## COMMENT RESPONSE DOCUMENT

EASA PAD No. 23-076

[Published on 16 June 2023 and officially closed for comments on 14 July 2023]

ICN-A320-A-53XX1493-A-FAPE3-02GZ7-A-003-01

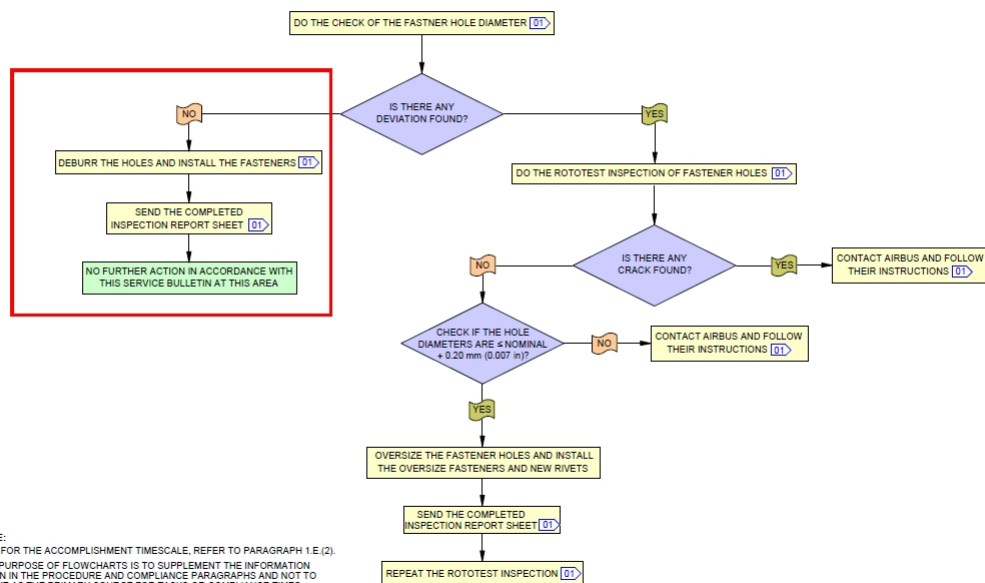
After reviewed PAD 23-076, we found the "Terminating Action" is None. While after reviewed SB A320-53-1493R00, there is one condition where this inspection can be terminated which is no deviation found of the fastener hole diameter of all affected areas. Please see the following flowchart.

So please consider whether it is necessary to include such condition of "Terminating Action" in PAD.

According to the SB compliance table, the flowchart figure ICN-A320-A-53XX1493-A-FAPE3-02GZ7-A-003-01 Fig.FA Sol.AA SHEET 1/1 of the SB A320-53-1493 and according to the webinar documentation related to that topic, in case of no deviation found during inspection according to AD §1, the inspected holes have to be deburred, fasteners installed and the completed inspection reporting sheet sent to Airbus. Thereafter no further action is required for that area.

That option is not described with the provided PAD. If the AD will be published without any information related to that, the inspection has also to be performed at the defined interval for areas without any deviations. Therefore DLH requests EASA to add a terminating option for areas where no deviations have been identified during inspection.

**EASA response: Comment #1 agreed. The final AD has been updated accordingly.**

**See answer for comment #1 for the terminating action. Additionally, a credit paragraph has been added in the final AD to address the above comment.**
